# TOWN OF KITTERY

### **ITEM 3—5 Whipple Road—Major Site Plan — Preliminary Review**

Action: accept site plan as complete. Schedule site walk/public hearing. Mike Sudak, on behalf of owner/applicants PB Real Estate Holdings LLC, request approval to construct a 3,400 square foot commercial facility containing a butcher’s shop and restaurant, along with associated parking and utilities, on the property of 5 Whipple Road, Tax Map 9, Lot 134, in the Business Local (B-L) Zone.

**RE: Minor Site Plan Review Application – Waiver Request Narratives  
Maine Meat Butcher & Restaurant  
5 Whipple Road, Kittery, Maine (Tax Map 9, Lot 134)**

STORMWATER: DEVELOPED CONDITIONS  
 MAINE MEAT BUTCHER & RESTAURANT  
 5 WHIPPLE ROAD, KITTERY, MAINE

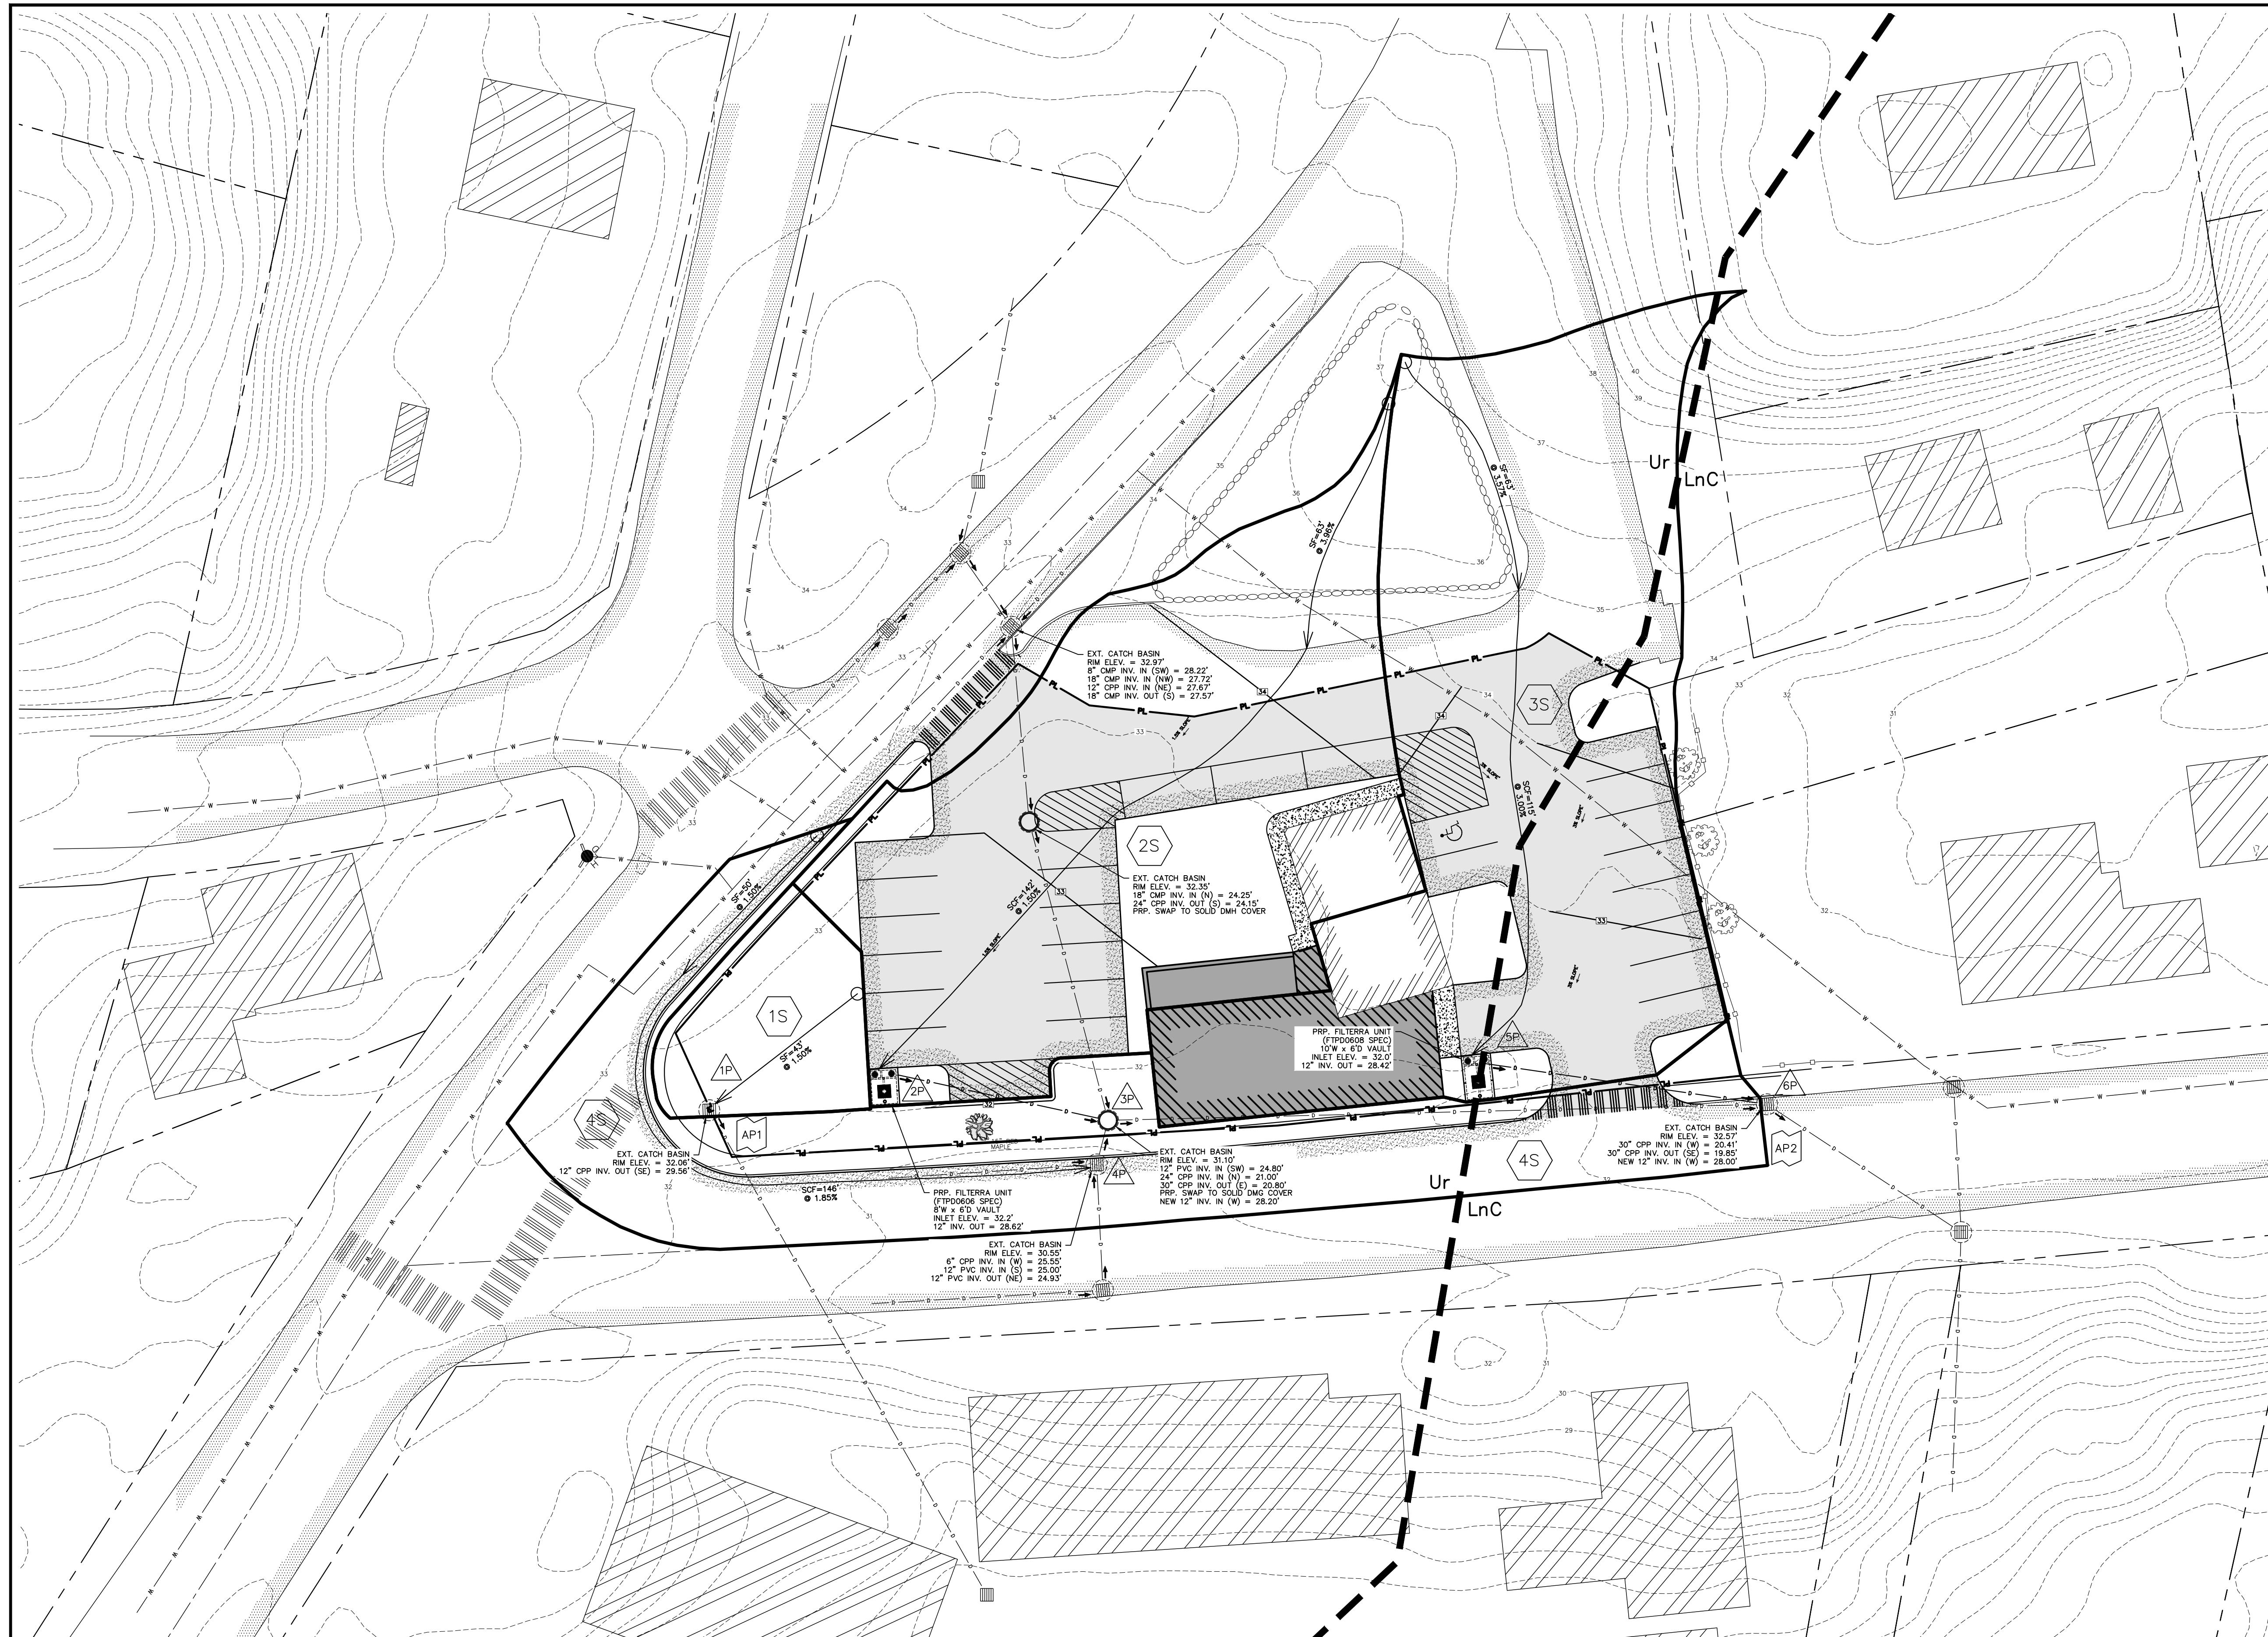
#### Sheet 8 – Stormwater: Developed Conditions
